Access Compliance Report

Public Rights-of-Way

(Curb Ramps)

Intersection ID: 52487	Main Street: WHITEHALL_EXECUTIVE_CENTER_DR	Cross Street: ORLICK_DR	Location: W
ADA ID: 6FFA99F4BF71	Ramp Type: Perp	Initial Pass/Fail: Pass	Overall Compliance: No
Severity Score: 2.5			
Codes/Mitigation Info/Possible Solution		Field Measurements/Component Compliance

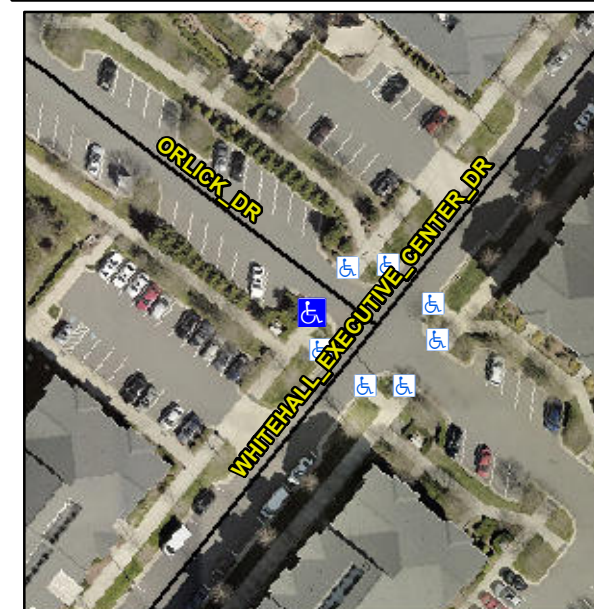
Remove & Replace Detectable Warning System.

R305.1.4
